Informal document GRVA-20-30  
20th GRVA, 23-27 September 2024  
Provisional agenda item 10

# UN Regulation No. 90 Bedding / burnishing procedure

## Cold performance results following R90 specified bedding

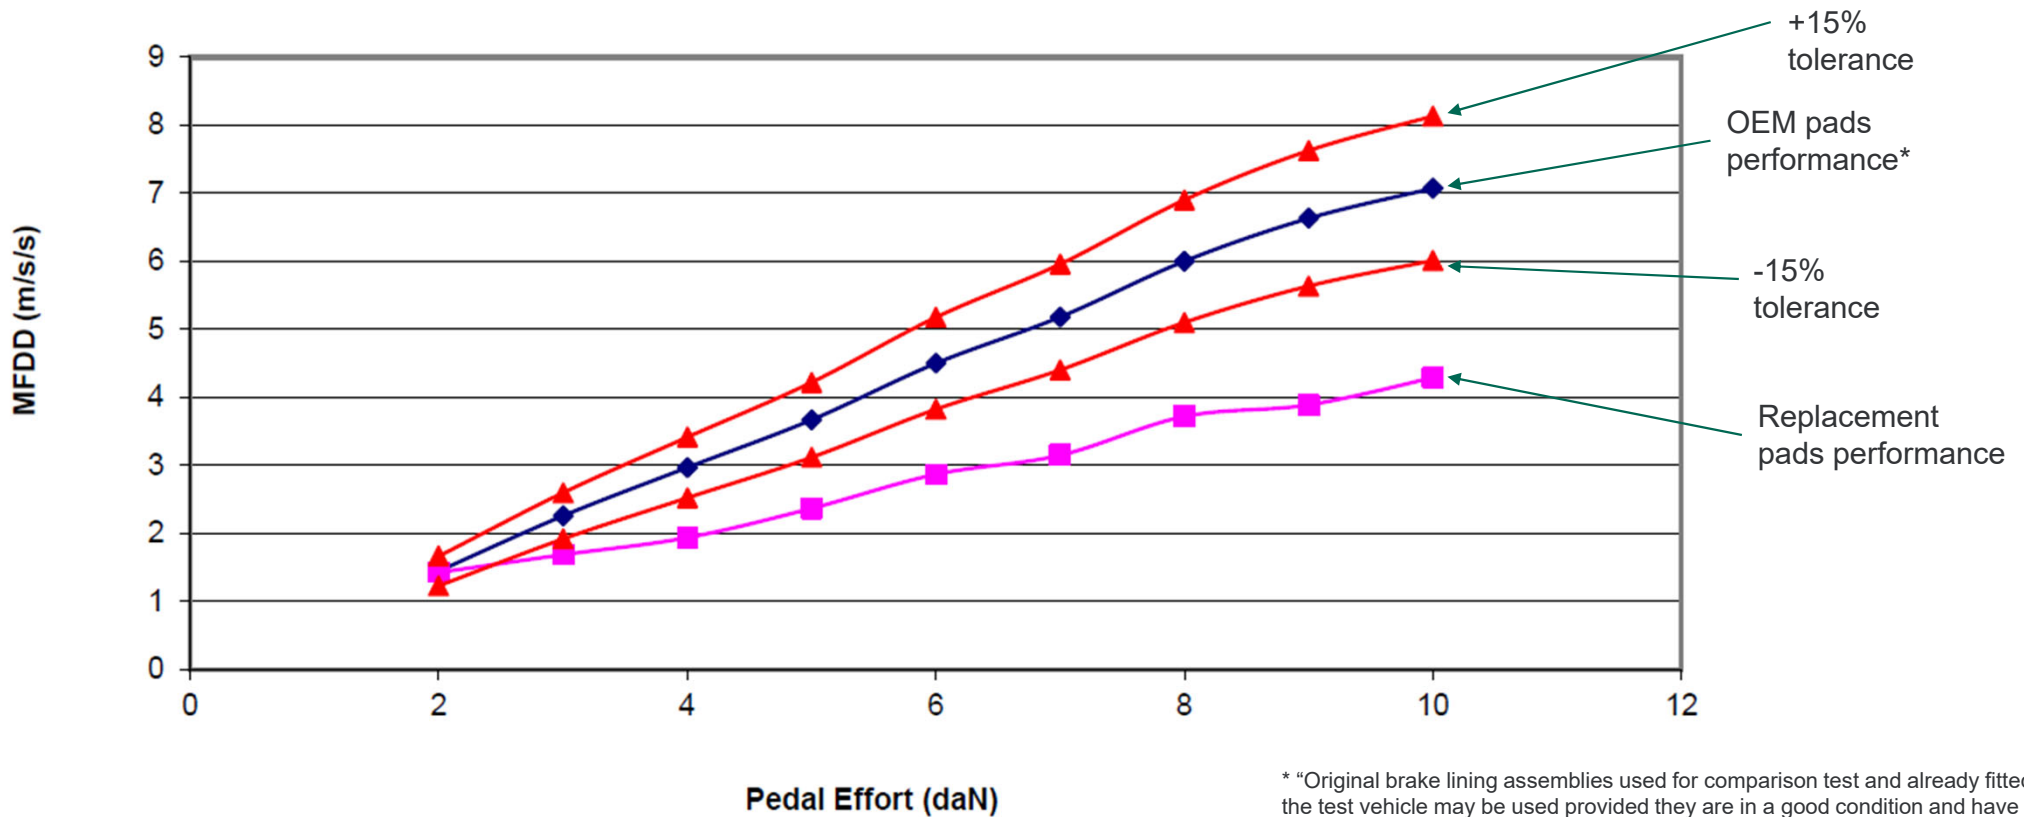
- ▶ The procedure in Annex 3 paragraph 1.1.2.2 appears to define the least 'intensive' bedding activity which can be deemed sufficient.
- ▶ It has been found that if a more intensive procedure is used (for example keeping the pad temperature in the range 250-500 °C for most of the bedding process, rather than just three times) the linings can show much better performance in the subsequent approval tests.

- ▶ Annex 3 paragraph 1.1.2.3 provides a check that the bedding is 'complete', however evidence shows that this check can be fulfilled even though the linings are not sufficiently bedded to achieve full performance in all tests.
